# Network Rail Track Renewals in Control Period 4

Site Inspection and Review of items proposed for renewal on Primary Routes in 2009/10 to assess the justification for the timing and the proposed engineering specification.

Richard Spoons Associates Ltd

**Figure 6. Kettering. View looking north from the four foot of the down main at the southern end of the site. 71 MP in the mid distance. Slow lines to the right.**

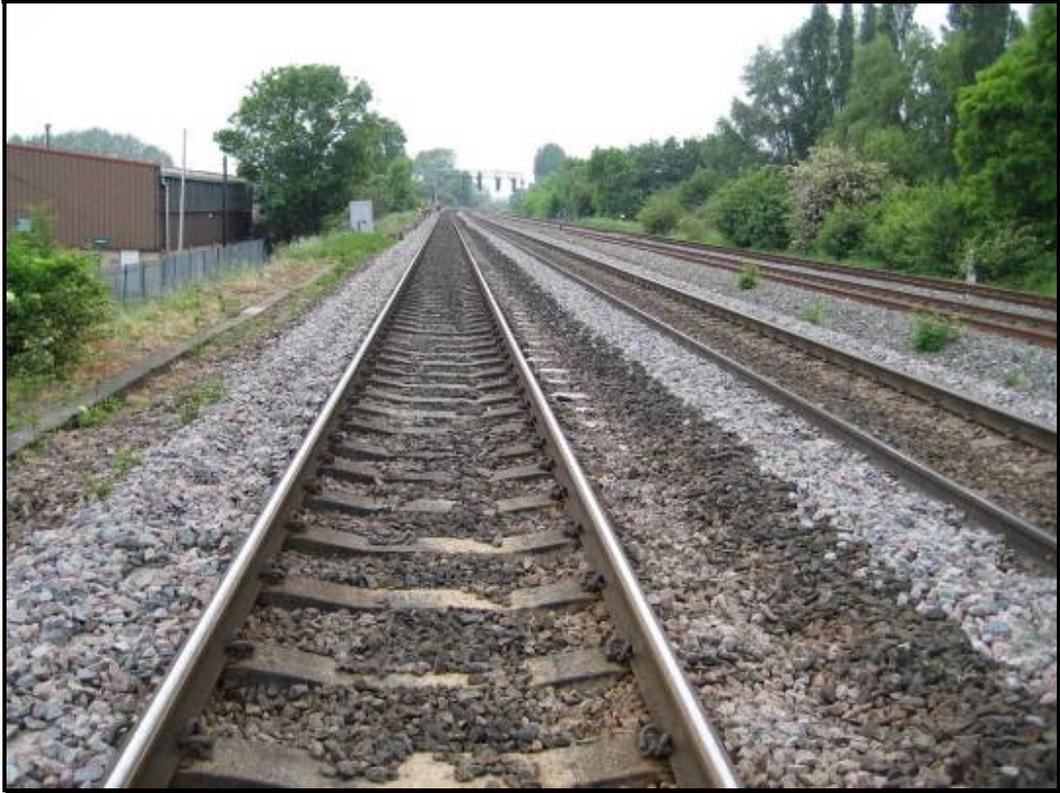
The track was installed in 1972 with 113A cwr; F27 sleepers and 401 pandrol fastenings. 7.5 mm pads were installed in 1995. The adjacent up main is the same age. Ballast conditions look good on the surface; however, trial holes have revealed an old formation treatment with Terram sheet overlaying sand. at the south end where there is an old drainage system leading up to and through overbridge No. 55 at 70m 1480y.

The track geometry data shows very poor standard deviation values for both top and line for the 220y off the S&C and through the under bridge. Top remains poor up to the 71 MP, after which both top and line revert to the 'good' standard.

The ballast conditions are not exceptionally bad, even though the trial holes only show localised failure of the sand/Terram treatment. Therefore improvements to the geometry should be possible for the two eighths of a mile that are in the poor and very poor categories by using a stoneblower. Similar maintenance treatment to the adjacent up line is also recommended.

It is recommended that a detailed track drainage scheme for both up and down lines is designed with associated formation treatment, particularly from the S&C and through the overbridge. When this is ready for implementation renewal of the rail, sleepers and ballast is justified from the S&C and up to the 1990 F40 cwr at 71m 30y on the down line. A separate proposal for the up line should be considered for later in CP4 such that its renewal and associated formation treatment will tie into that constructed for the down line.

Up to two years whilst the drainage and formation treatments are scoped and designed for both up and down lines.

**Figure 13. Diss S&C and up siding from the down main line looking north**

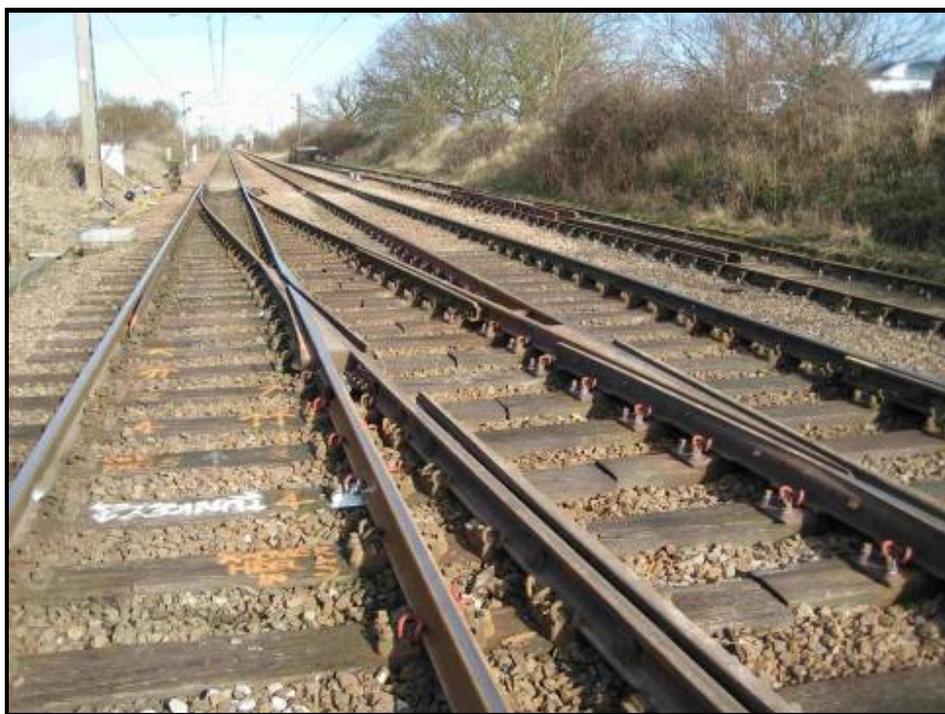
The crossover in the main lines was installed in 1973. It is a vertical timbered layout with 113A rail and hardwood timbers. The switches are original, but the crossings were renewed in 1990 and 2005. The general condition is good, helped by the straight alignment of the main lines and the fact that train speeds are low as all passenger trains are running at slow speed for their stop at the station.

The facing connection into the up siding was installed in 1976 to the same specification as the crossover. The switches are original; however the crossing was changed in 2002. The trailing connection into the up siding was installed in 1973. The right hand switch was renewed in 2000 and the crossing in 1990.

The overall condition of the four units is good and renewal in CP4 cannot be justified. The weakest components are the timbers which have started to delaminate. There was no evidence of baseplate indentation found. This is an example of a layout on a 100 mph route which is not subject to normal wear and tear from traffic as there is very little through freight and all passenger trains stop at Diss station.

It was noted that some replacement ironwork had been ordered and was lying in the sidings area. This layout is ideal for life extension treatment.

Yes. Due to the proximity of this site to Diss station, which results in lower speeds, this layout is ideal for life extension treatment as described for Barham S&C above.

Figure 17. Basingstoke down fast looking toward London.

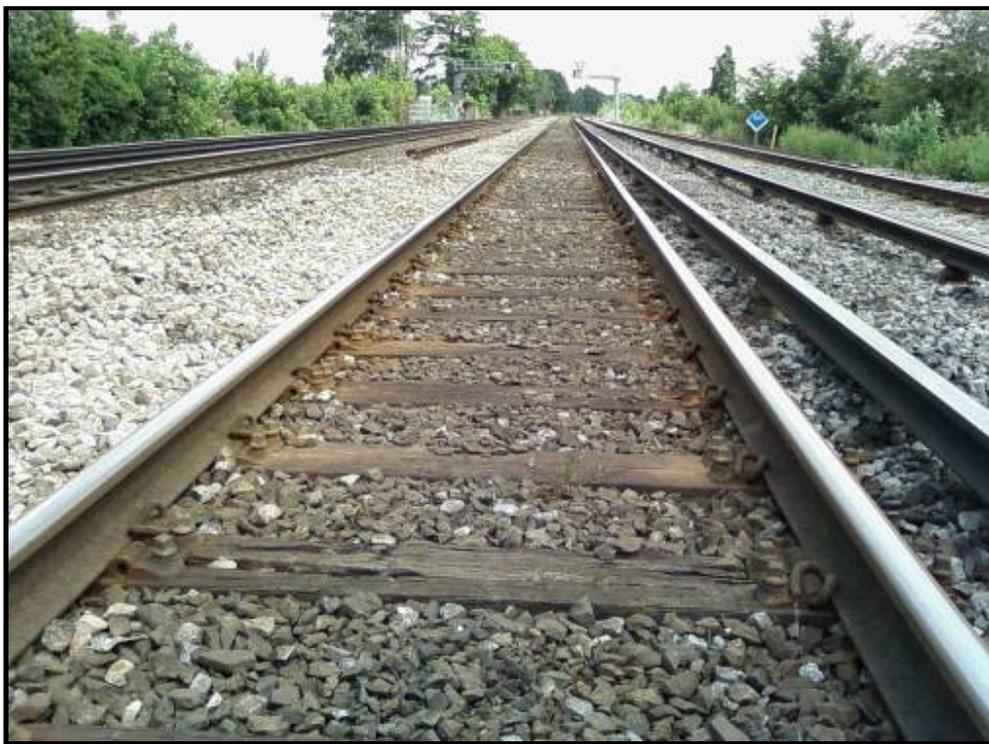
The proposal is to renew 575 yards on the down fast between Basingstoke station and Worting Junction in 2009/10. There are four tracks leading up to Worting Junction. The down fast and down slow are separated from the up fast and up slow by a tenfoot. The route speed is 100 mph although the linespeed at this location is 90mph. The site proposed for renewal commences at 49m 1412y and abuts the London end of Worting Junction at 50m 229y. The earliest material indicates an original installation year of 1963. The 110A rail sits on Pan 11 baseplates secured to wood sleepers. EGMTPA have increased since the BR class 442 multiple units which operated the services to Bournemouth have been replaced by heavier class 444/450 units. There is evidence of the track system coming to the end of its economic life with gall in the rail foot over the baseplates and several baseplates spikes are loose with corresponding indentation on the sleepers. Sleeper condition is poor with evidence of decay on the surface. Ballast is crushed and dirty with fines, resulting in stoneblower being the only effective geometry maintenance tool. The track alignment is on a gentle curve leaving Basingstoke station then running straight up to Worting Junction, which, together with a naturally draining formation and shared route tonnage with the slow line, is the reason this site has lasted for 45 years. Geometry traces

recorded in May 2008 show good alignment but less than good twist and top traces with some general gauge widening. EGMTPA is 11.0.

Figure 20. Basford hall junction 52B points looking north.

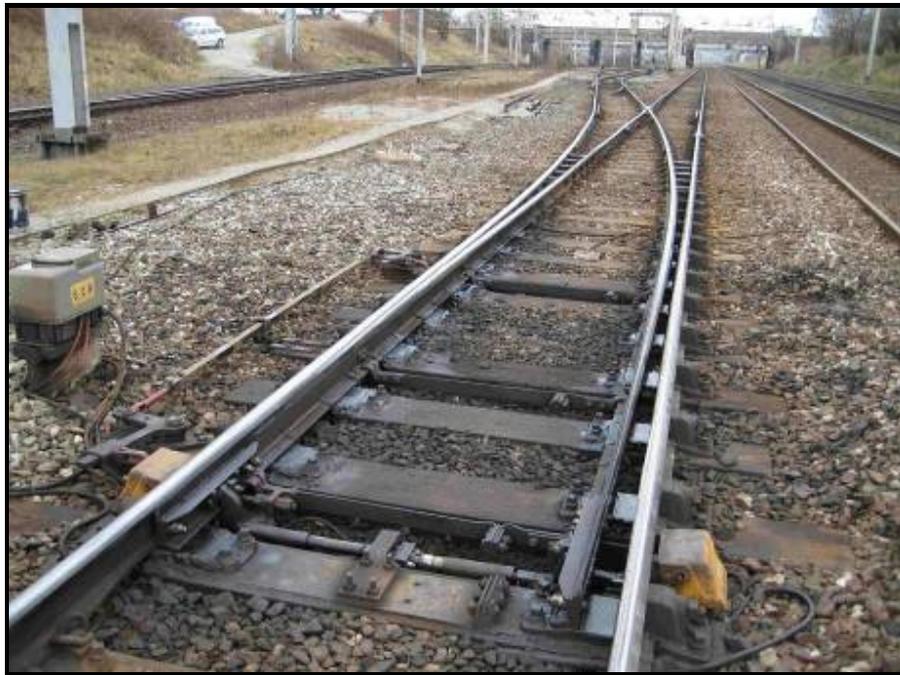
The proposal was for the complete renewal of 52B and 52A points in 2011/12. The points form the up exit road from the Independent line and the sidings complex. 52A points are the trap providing flank protection when the down slow points are set normal.

The layout was installed in 1971 and is made up of 113A vertical rail on hardwood timber bearers. The switches to 52B points were renewed in 1998 (LHS) and 2001 (RHS). The crossing was renewed in 2003. Both sets of switches were renewed at the trap points; LHS in 1987 and RHS in 2005. The ballast conditions are poor with no effective drainage system. The timbers are showing signs of delamination and several have been changed. This is a slow speed high tonnage connection.

**Figure 32. Dalmakethar up line looking north**

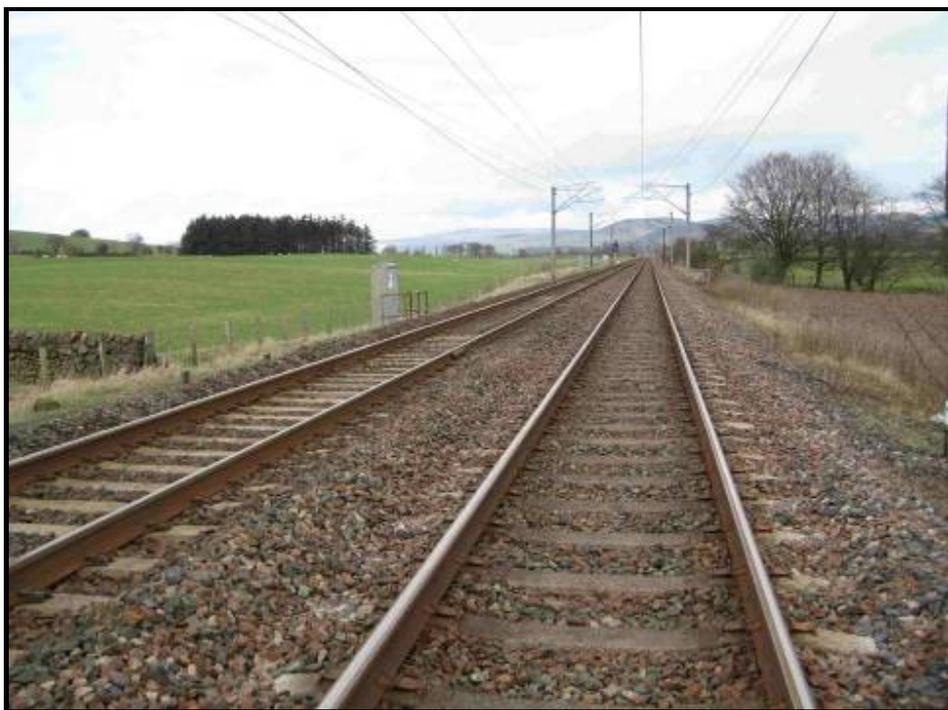
The third plain line renewal item inspected in Scotland is a proposal to totally renew 1,334 yards on the up line between 33miles and 32 miles 426 yards. The existing track was installed in 1965.

The track is early CWR with F19 concrete sleepers and SHC fastenings laid at 700 mm centres (26 per 60 foot) in 1967. The track is straight and the recent records of track quality show all parameters in the good band. Rail age is 1967. The track is on a slight embankment giving good drainage to the cess. This is a stretch of railway appearing to give no undue problems to the

**Figure 41. Corsham. Down line looking towards London**

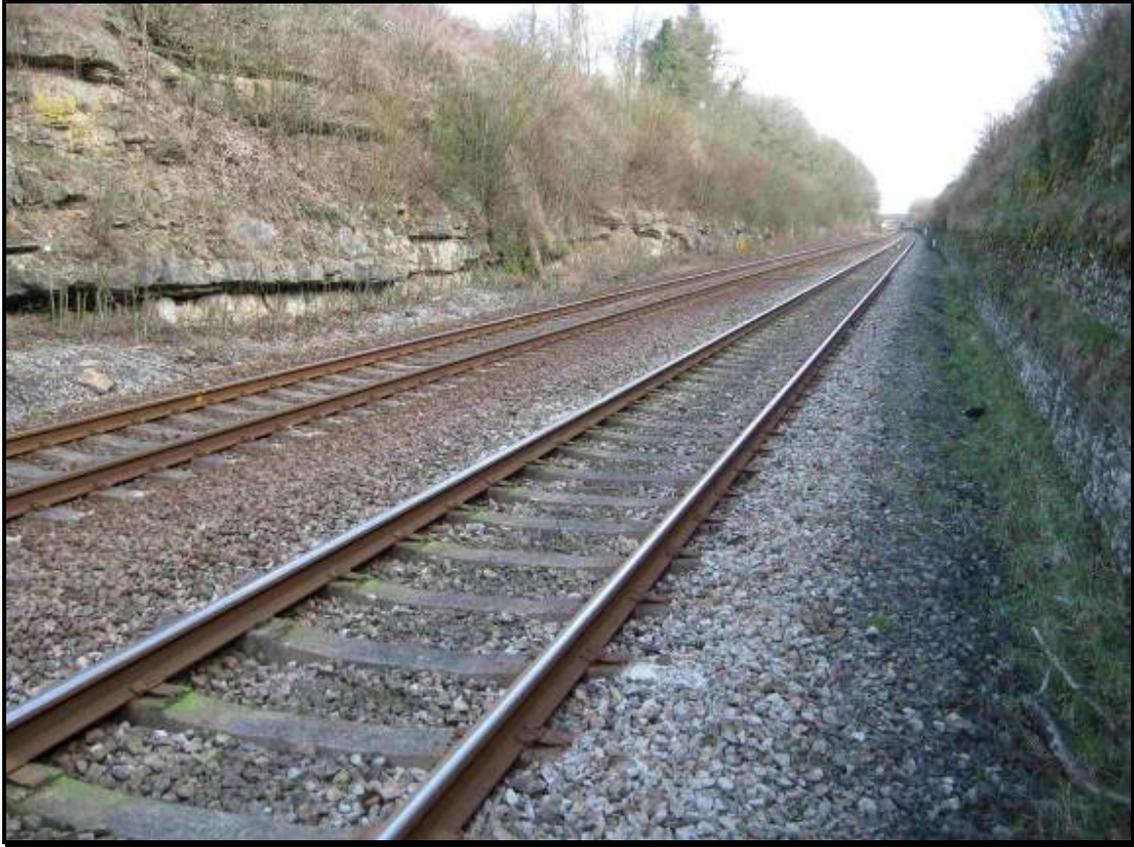
The item is on a straight alignment in a cutting leading up to the east portal of Box Tunnel. Installed in 1966 this early cwr item has F19 sleepers and SHC fastenings. There is a history of rail defects. The ballast is dirty; however, the observed track geometry is good. Water can drain naturally to the cess and there is a drain in the six foot.

The track category is 1 and the EMGTPA 10.5. It is the relatively low annual tonnage and well drained ballast that has contributed to this section of track giving such good service. Now the track is starting to show that age with dipped welds and contaminated ballast. The modeled service life is 35 years for sleepers and 40 years for rail. Both will be exceeded when this item is renewed in 2009/10.

None. Deferral is not recommended due to the potential weakness in the already dipped SmW welds in 1966 rail which could lead to rail failures. SmW is the trade name of a welding process used by BR from the 1950s. The process relied on the judgment of the welding team to ensure the correct pre heat had been given to the rail ends before the molten Thermit portion was dropped into the mould. In 1974 a new process with fixed pre heat parameters and a larger Thermit portion was introduced. This, the SkV process, produced a more reliable weld and SmW was discontinued. It follows that older cwr from before 1974 has welds that are more prone to failure.
